IMPORTANT SAFETY RECALL 20V-168
This notice applies to your vehicle

Terex Utilities	
SAFETY NOTICE	SN684

MODELS AFFECTED: TCX60/85, XML65/90

SUBJECT: 25 ft Double Lift 497981 & 498199

Issue:

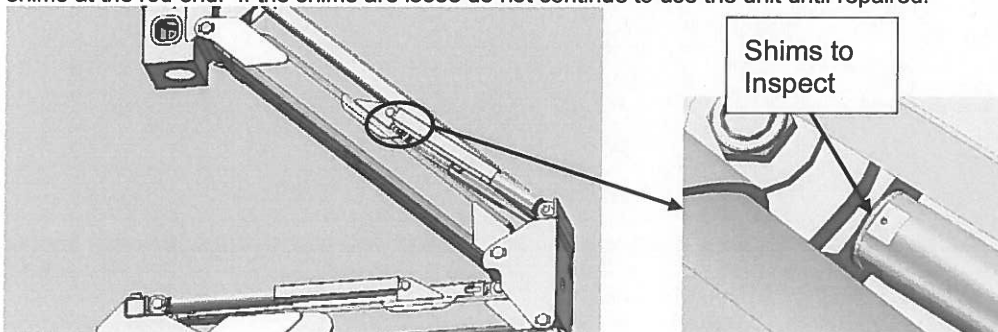
The 25 foot double lift, part numbers 497981 & 498199, have shims which do not fully support the elevator cylinder rod eyes. The threaded portion of the rod eye may fatigue and fail causing the lift to drift down. If one rod eye fails the lift is only supported by one of the two cylinders. **The aerial boom may drift down contacting lower levels causing injury.**

Terex will provide replacement rod eyes and shims for all 4 cylinders at no cost to the owner. Field Service kit Z1582, which will repair all four cylinders, will be provided to the nearest Terex Utilities dealer or Field Service Technician for installation on your unit.

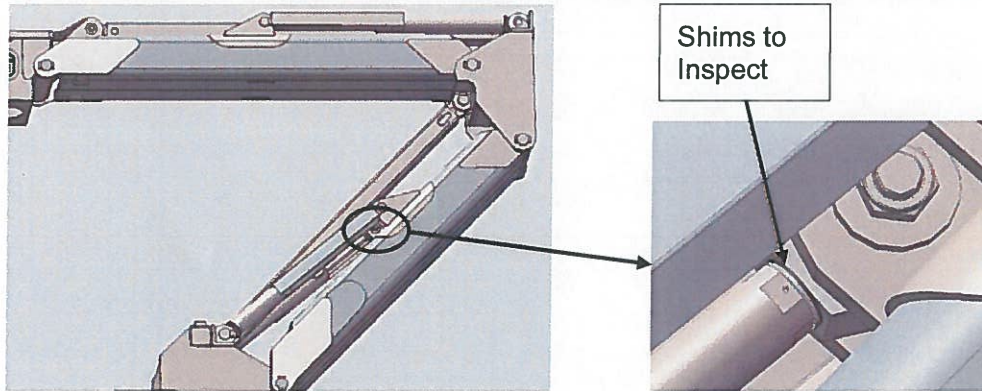
1. From the lower lift controls raise the upper lift boom to 45 degrees and look under the cover at the shims at the rod end. If the shims are loose do not continue to use the unit until repaired.

3. If the shims on all four cylinders are still tight follow the continued use statement below.
4. If any of the shims are loose it indicates the rod eye is not torqued properly. The rod eye and shims must be replaced before further use.
